URGENT FIELD SAFETY NOTICE

Subject: Incorrect handling of non-square Image pixel spacing in Enterprise Imaging XERO Viewer at initial load leads to incorrect placement of reference lines.

- Enterprise Imaging XERO Viewer (UDI-DI: 05400874000710)

Figure 1: Example of placement difference due to incorrect initialization in XERO Viewer

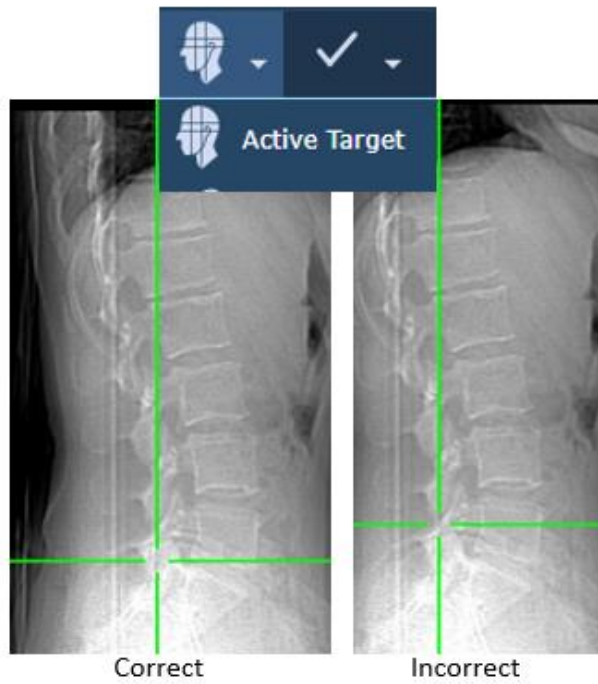
When an image has non-square pixel spacing, the reference/localizer line is incorrectly placed on the scout image in the XERO Viewer (offset from actual position). For example, when viewing a CT localizer radiograph, also known as a scanogram or scout image in the sagittal plane next to an axial series, the localizer/scout line or the active target localization tool may display the incorrect crosshair/line position on the non-coplanar/scout image with respect to the axial slice location.

This misplacement occurs only initially when viewing the anatomy in the non-coplanar image within XERO Viewer. When a user scrolls through other available scout/non-coplanar images in a series, or replaces the current image in the display area with another series and then returns to the first scout image viewed, the reference/localizer line or active target crosshair will subsequently be correctly placed.

AGFA HealthCare will provide the software corrections for the affected versions. A patch is available for each of the following XERO Viewer version streams:

- Use the XERO Viewer Extended Tools component (Xtend), if enabled.
- Use the Enterprise Imaging Desktops viewer
- Scroll through other available scout/non-coplanar images in a series, or replace the current image in the display area with another series in order to correct any potentially misplaced scout line.
